Access Compliance Report

Public Rights-of-Way

(Curb Ramps)

Intersection ID: 12998	Main Street: 5TH_ST	Cross Street: MCDOWELL_ST	Location: E
ADA ID: 79A897EF9C4B	Ramp Type: Perp	Initial Pass/Fail: Pass	Overall Compliance: No
Severity Score: 20.25			
Codes/Mitigation Info/Possible Solution		Field Measurements/Component Compliance

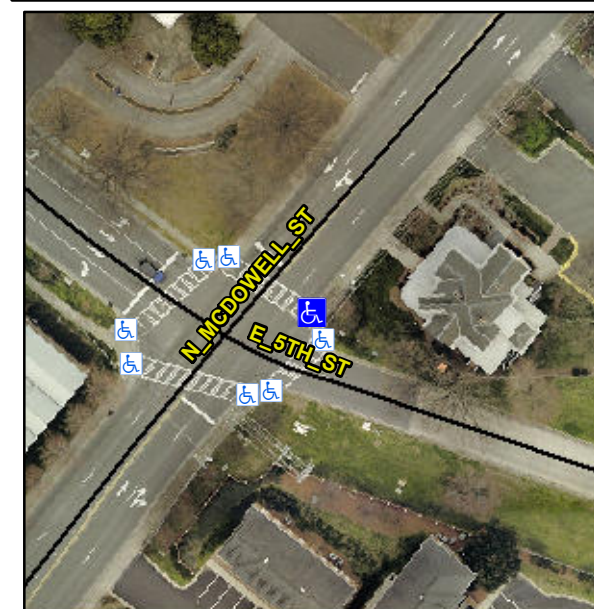
**Not Found, R304.5.3, R304.2.1,
R304.2.2-Perp, R304.3.2-Para,
R304.2.3, R305.2, R304.5.4**

Compliance	Description	Data	Compliance	Description	Data
N/A	Ramp Length (in)	70.0	Yes	Ramp Slope (%)	7.9
Yes	Ramp Width (in)	54.0	No	Ramp XSlope (%)	4.2
N/A	Flare Type LT	Sloped	N/A	Flare Type RT	N/A
N/A	Flare Slope LT (%)	8.9	No	Flare Slope RT (%)	12.6
N/A	Flare Traversable LT?	Yes	N/A	Flare Traversable RT?	Yes
No	Landing Length (in)	N/A	Yes	DWS Provided?	Yes
No	Landing Width (in)	N/A	Yes	DWS Contrast?	Yes
No	Landing Slope (%)	N/A	Yes	DWS Length (in)	24.0
No	Landing X Slope (%)	N/A	Yes	DWS Full Width?	Yes
N/A	Landing Curb? (Y/N)	No	No	DWS Offset (in)	4.5
N/A	Shared Landing?	No			
Yes	Gutter Ponding?	No	No	Gutter Slope (%)	5.3
Yes	Gutter Lip Ht (in)	0.0	Yes	Gutter X Slope (%)	0.9
N/A	Painted X Walk1?	Yes	N/A	Painted X Walk2?	N/A
	X Walk 1 Direction	To NW		X Walk 2 Direction	N/A
N/A	X Walk 1 Width (in)	111.0	N/A	X Walk 2 Width (in)	N/A
	X Walk 1 Slope (%)	1.0		X Walk 2 Slope (%)	N/A
	X Walk 1 X Slope (%)	3.1		X Walk 2 X Slope (%)	N/A

**Remove & Replace Entire Ramp.
Remove & Replace Gutter.**
